Staff Report for Item 12a

To:	Chairman Bryan Green and Historic Architectural Review Commission Members
From:	Kelly Perkins, MHP HARC Assistant Planner
Meeting Date:	June 23, 2015
Applicant:	William Horn Architects
Application Number:	H15-01-0842
Address:	#616 Eaton Street

Renovations to contributing house. New rear addition. New two-story residence in rear of property. Site work.

1 NEW BLDG. - NORTHEAST ELEVATION
1/8" = 1'-0"

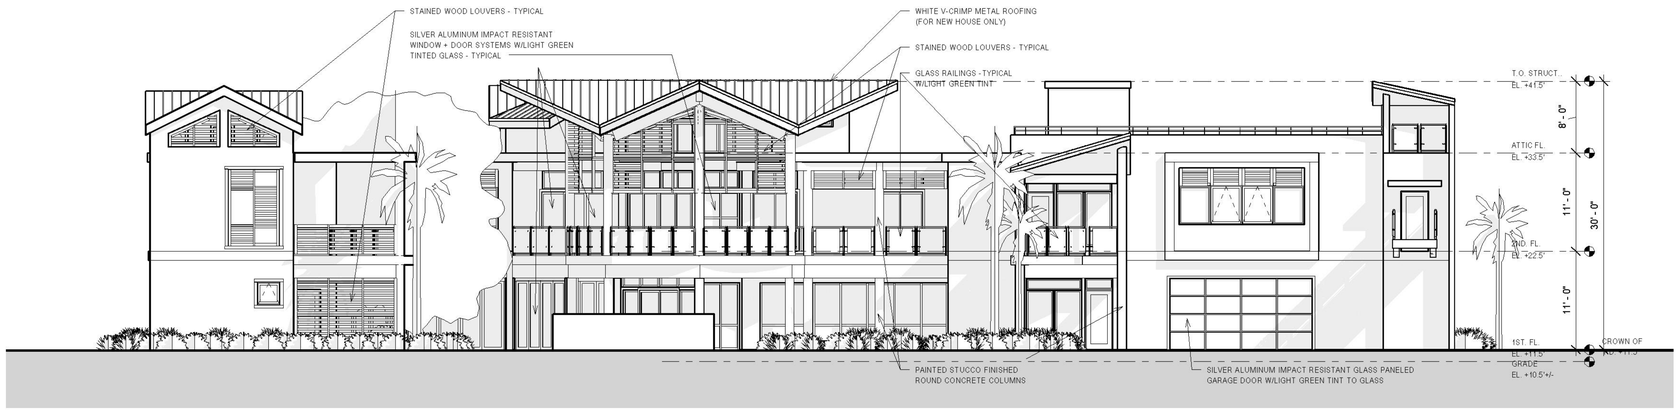
3. The new residence in the rear is very large and massive. The guidelines for "Proportion, scale, and mass" say that "no new construction shall be enlarged so that its proportions are out of scale with its surroundings…No structure shall outsize the majority of structures in the streetscape or historic zone." The new house will not be on the street and will have little effect on the Eaton streetscape, and the structures in that area are mostly two to two-and-a-half stories tall. While height-wise, it won't be taller than surrounding houses, it will have a much larger mass and scale than adjacent buildings. The Compatibility guideline retains the theme saying, "All new construction must be in keeping with the historic character in terms of size, scale, etc."

a new residence behind the historic house. Although the house is located in the rear of the property, it is massive and out of scale compared to the neighboring historic structures. Therefore the new residence is inconsistent with the guidelines in regards to proportion, scale, and mass and compatibility.
